Access Compliance Report Public Rights-of-Way (Curb Ramps)

Main Street: **OSO_PKWY** Cross Street: **LOS_PATRONES_PKWY** Location: **NW**

ADA ID: **RPRK211021115302** Ramp Type: **Type 1 - Perpendicular Diagonal** Initial Pass/Fail: **Pass** Overall Compliance: **No** Severity Score: **0**

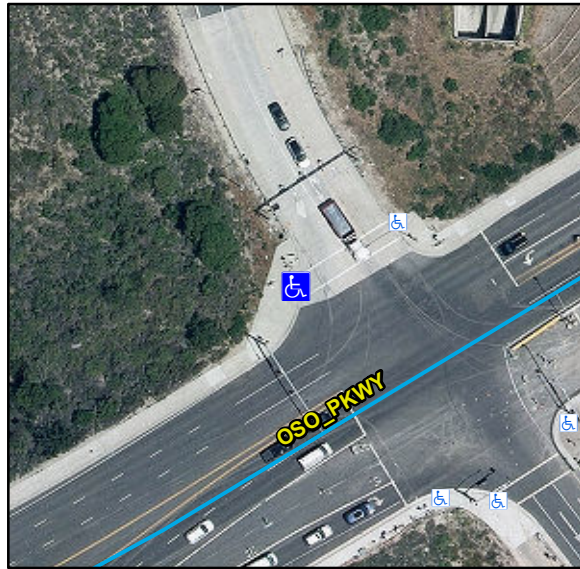
Remove & Replace Curb Slope.

R304.2.2, STD 1115
